Energy to Serve Your World™
NL-03-0815

April 11, 2003

Joseph M. Farley Nuclear Plant
Responses to NRC Questions on
Relaxation Request to Order EA-03-009

**SNC Response to NRC Questions on
Relaxation Request to Order EA-03-009 Item IV.C.(1)(b)(i)**

Figure 7
Hoop Stress Vs Distance from Top of Weld
40.0° CRDM Penetration Nozzle –Downhill

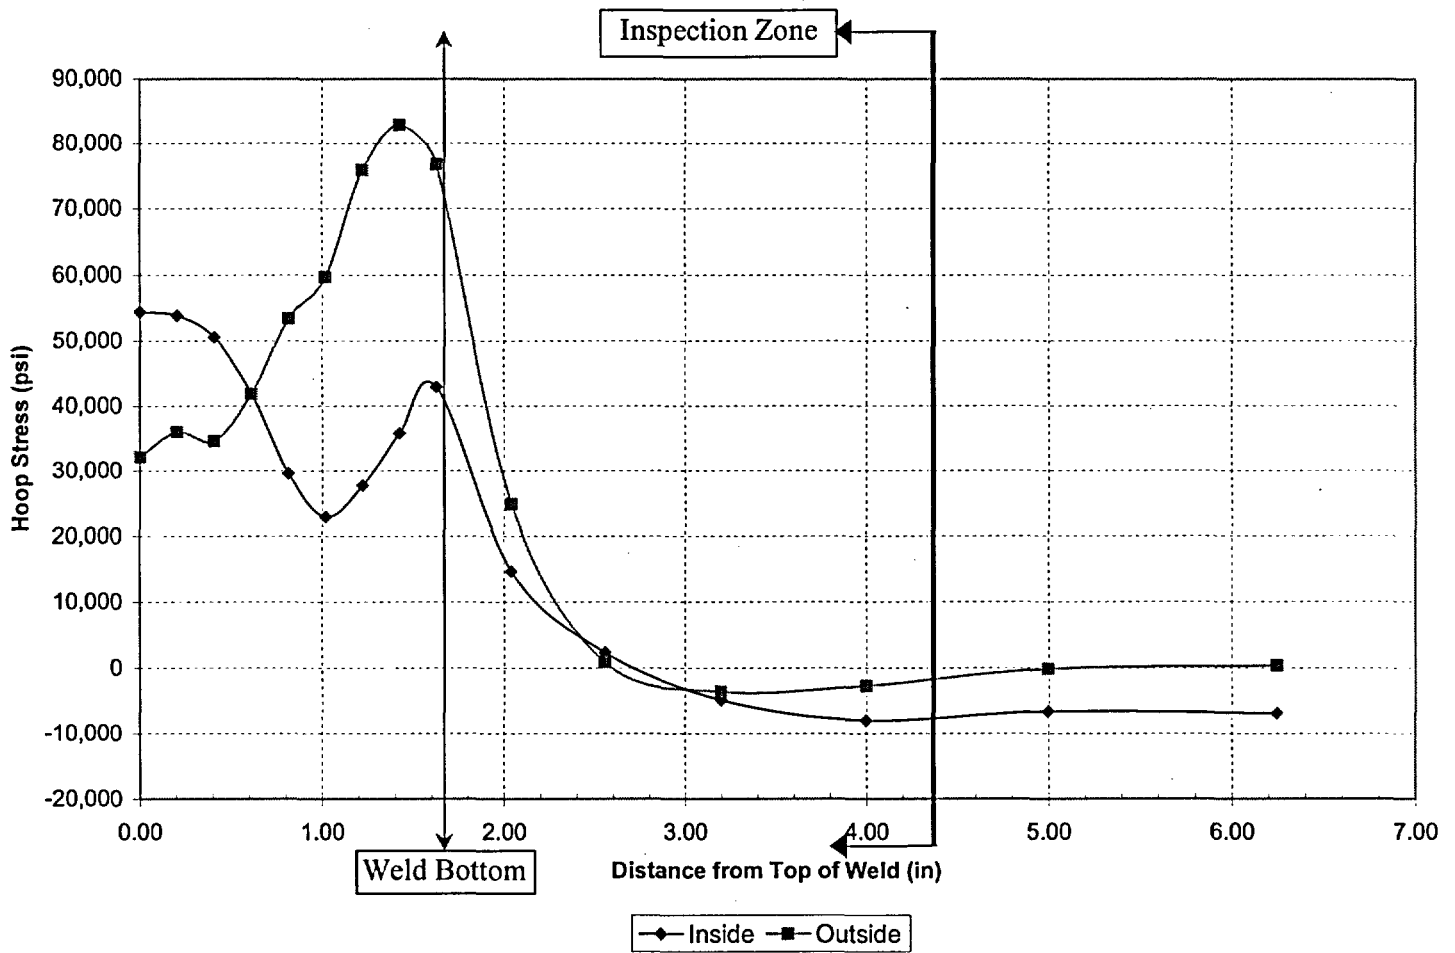
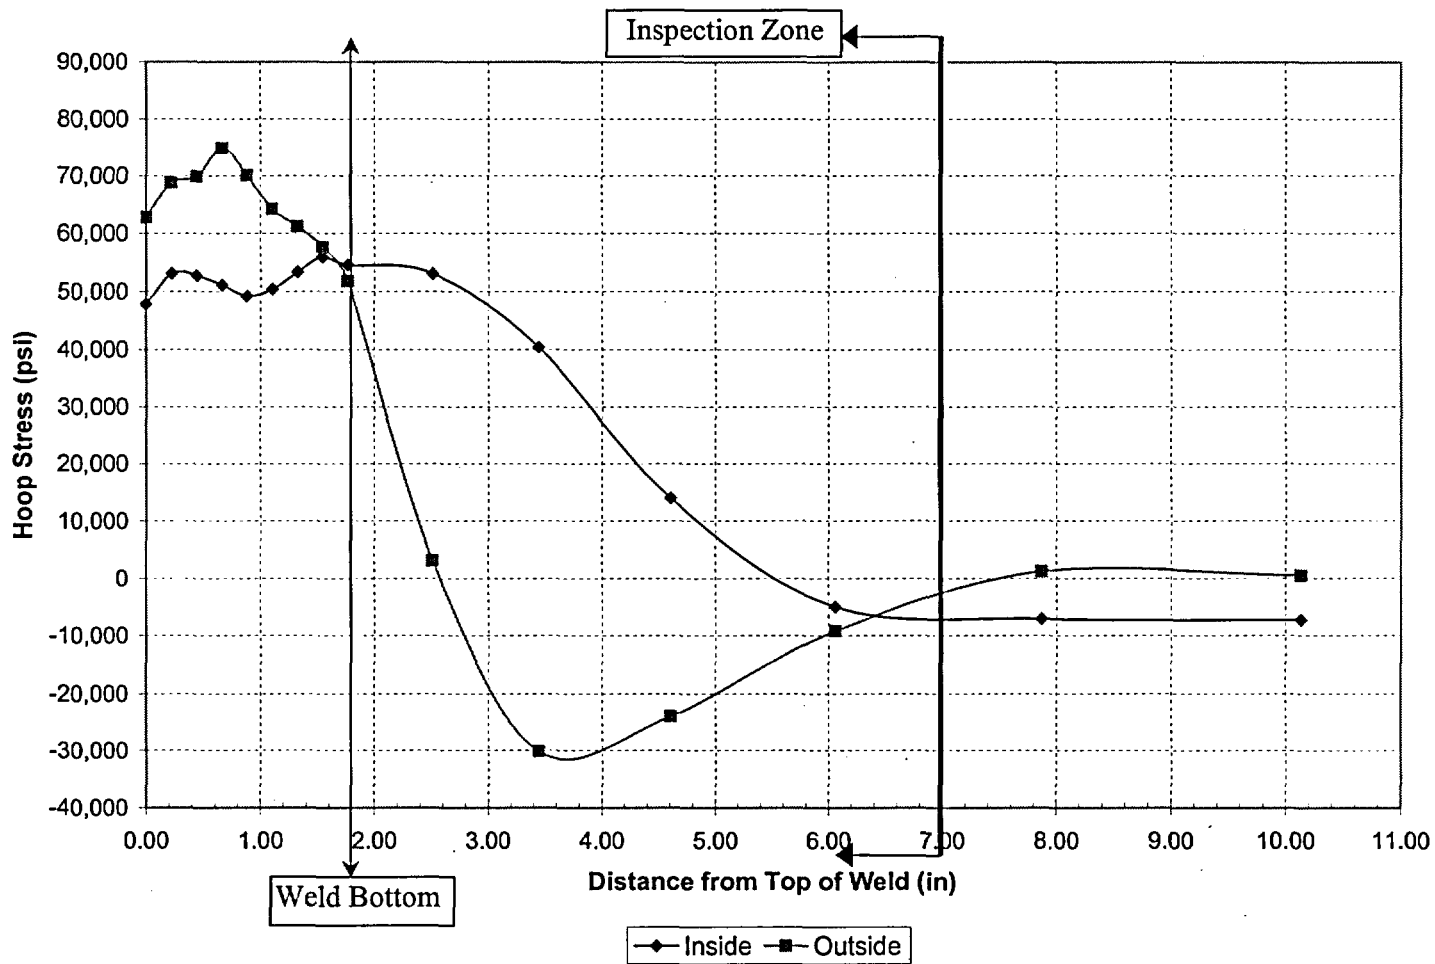
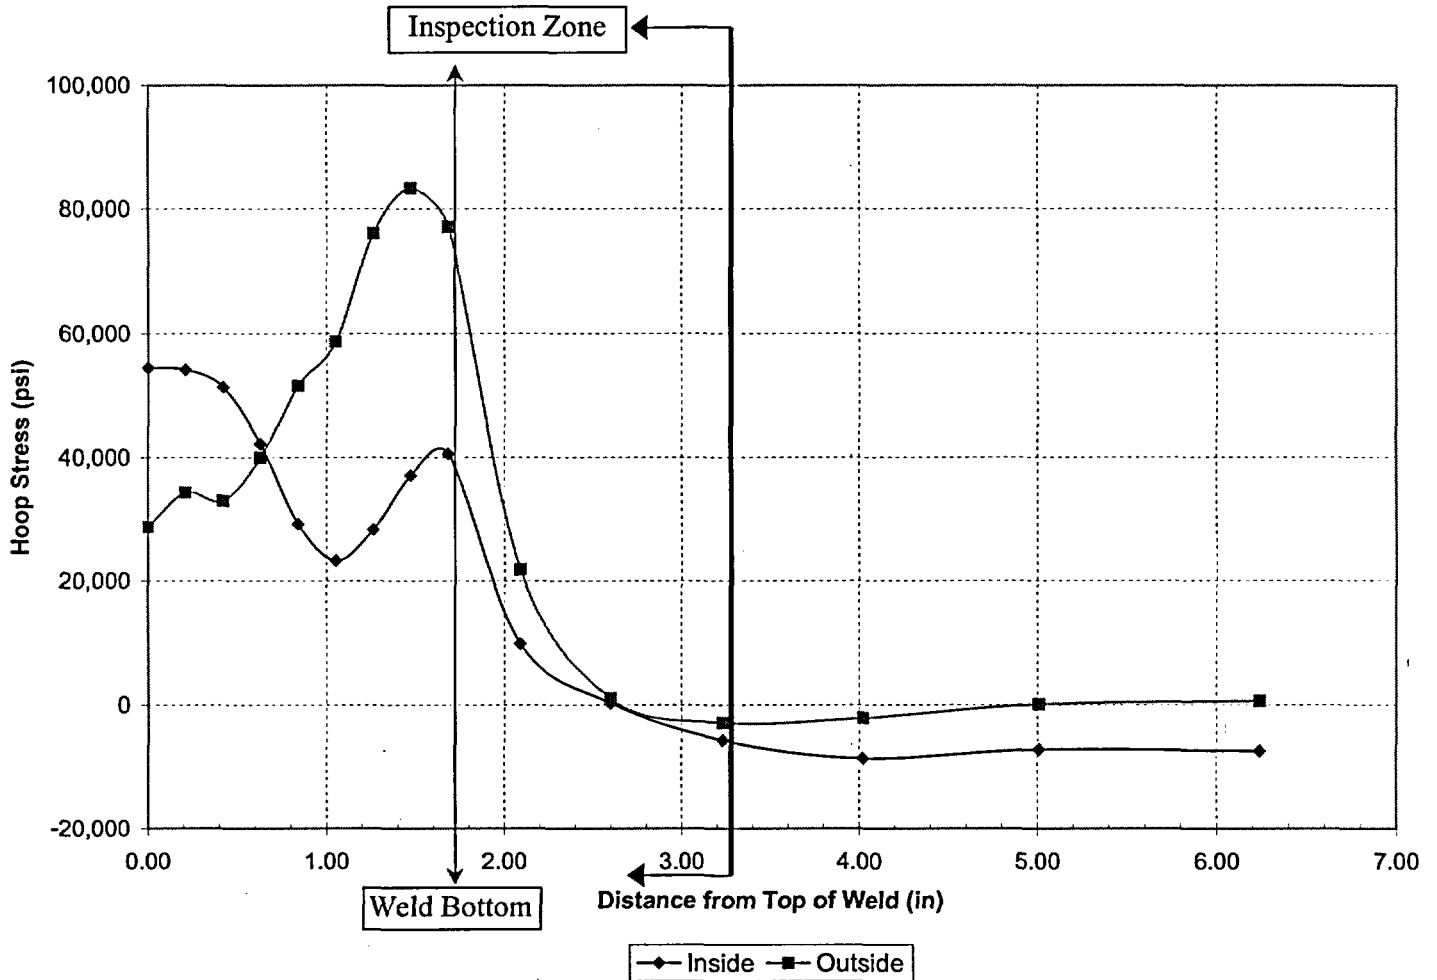
2. In your letter dated March 3, 2003, you stated that "UT of the most highly stressed portion of the nozzle is unaffected by this limitation." Please provide the stress profiles from the stress analysis in the J-groove weld region (across the cross-section) from the top of the J-groove weld to areas below the weld.

The hoop stress distributions, as a function of distance from the top of the weld for a range of penetration nozzle locations from the center of the RPV head to the outermost row, are provided in Figures 1 to 9. These stress profiles represent an alternate presentation of results from the analysis performed by Westinghouse for both FNP units as part of WCAP-15925-P, "Structural Integrity Evaluation of Reactor Vessel Upper Head Penetrations to Support Continued Operation: Farley Units 1 and 2." The expected zone of inspection coverage is also identified in each Figure. As shown in Figures 1 to 9, the magnitude of the stresses in the unexamined portion of the nozzles is low. The end data point is based on the stress model and not the physical end of the penetration tube.

Figure 10
Through-Wall Axial Flaws Located in the 28.6 Degree Row of
Penetrations, Uphill Side - Crack Growth Predictions

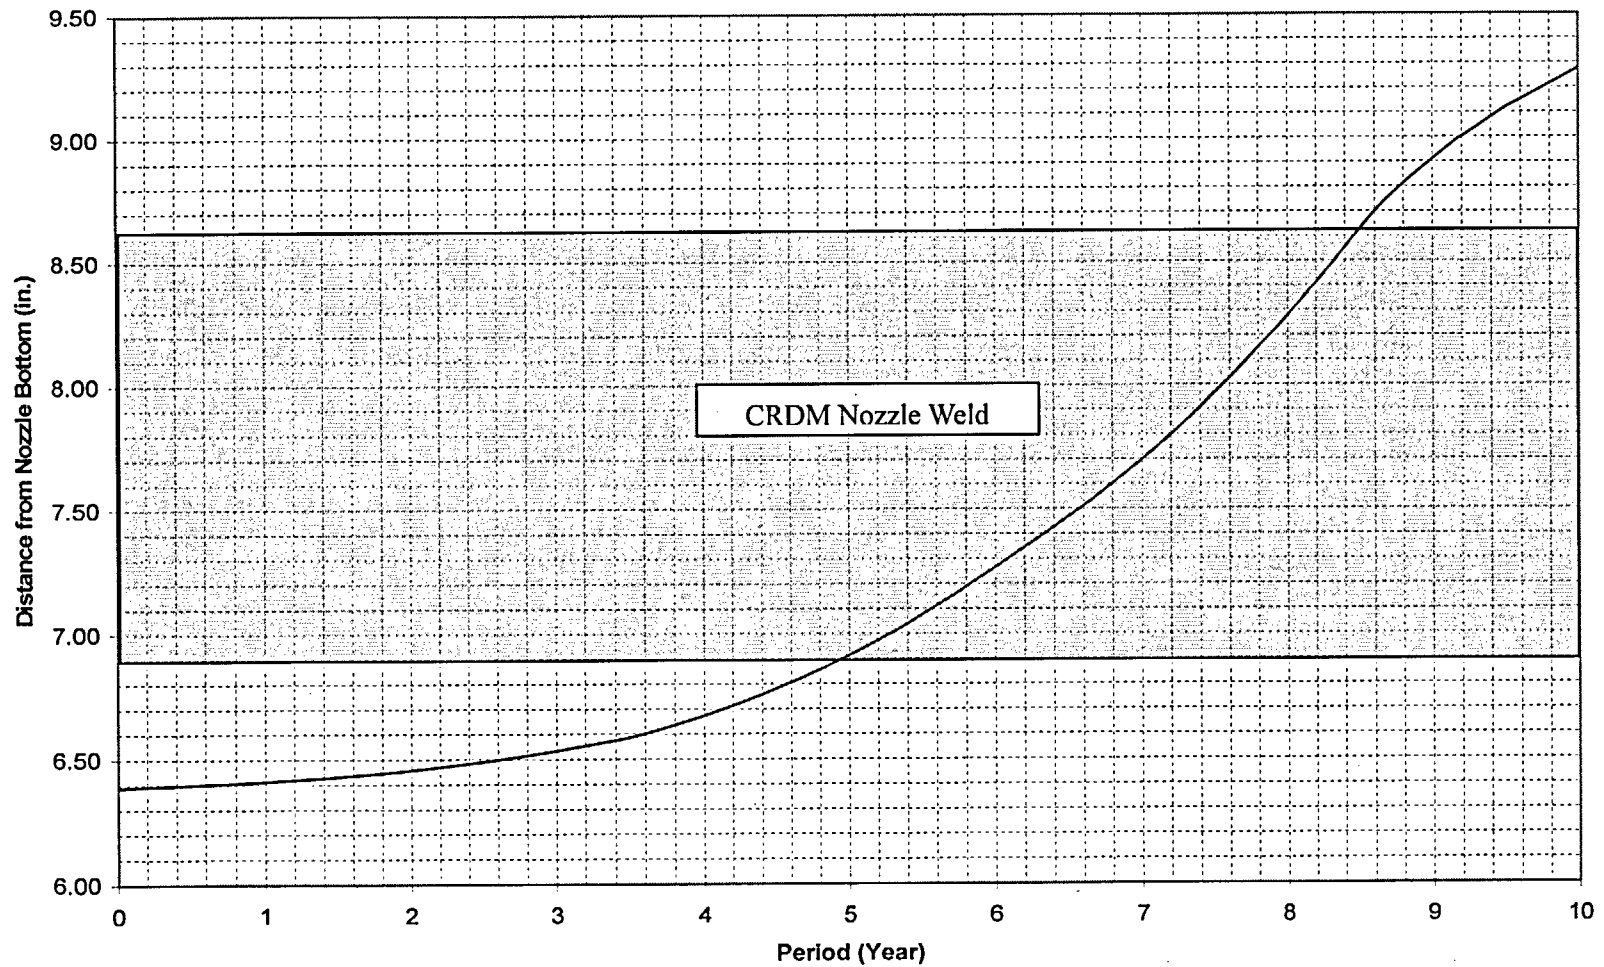
3. In your letter dated March 3, 2003, you also stated that, "cracks initiating in the unexamined bottom portion of the nozzle would be of minimal safety significance with respect to pressure boundary leakage or nozzle ejection, since this portion of the nozzle is several inches below the pressure boundary and any cracks would have to grow through a significant examined portion of the tube to reach the pressure boundary." Please provide technical basis, such as an analysis or an evaluation, to show that cracks initiated from the unexamined area will not propagate into the pressure boundary within one operating cycle based on conservative crack growth rate from the industry operating experience.

Axial flaws initiated in the unexamined non-pressure boundary portion of the nozzle base material below the weld are of minimal safety significance with respect to pressure boundary leakage or nozzle ejection. The expected examination coverage from the bottom of the J-groove weld towards the bottom of the nozzle is shown in Figures 1 to 9 (See the Response to Question 2). To determine the significance of such an axial flaw located in the unexamined portion of the nozzle below the weld, a flaw tolerance approach is used. A flaw evaluation was performed postulating an axial flaw in the area of missed coverage below the weld based on Farley Unit 1 specific stresses in the nozzle penetrations. The evaluations performed are based on a methodology consistent with the recently approved Section XI flaw evaluation approach, with a Primary Water Stress Corrosion Cracking (PWSCC) crack growth rate that is consistent with the MRP-55 Rev. 1 report. A through-wall axial flaw was postulated in the nozzle material growing upwards towards the bottom of the weld. Since the stresses for the unexamined portion of the nozzle below the weld are too low (See Figures 1 to 9 in the Response to Question 2) to propagate an axial flaw, the flaw evaluations start at 0.5" below the weld and the time to propagate the flaw in the nozzle to the bottom of the weld (start of the pressure boundary portion of the nozzle material or toe of the J-groove weld) was determined. Assuming a through-wall flaw below the weld, with the flaw end located at 0.5" below the weld (which is in the area of complete UT examination coverage), an axial flaw would take approximately 5 years of operation to grow to the point of contact with the weld; and even longer to grow from the bottom of the weld upwards through the pressure boundary. This time period is significantly greater than the current inspection frequency of every refueling cycle (18 months for FNP) identified in NRC Order EA-03-009.

Figure 10 provides a graphical presentation of the above flaw evaluation discussion for the limiting penetration location. Based on the crack growth results shown in Figure 10, there are no concerns with the structural integrity of the RPV head penetration nozzles that could be caused by axial cracking in the unexamined non-pressure boundary portion of the nozzle material below the weld (See Figures 1 to 9 in the Response to Question 2) for a period of approximately 5 years of operation.
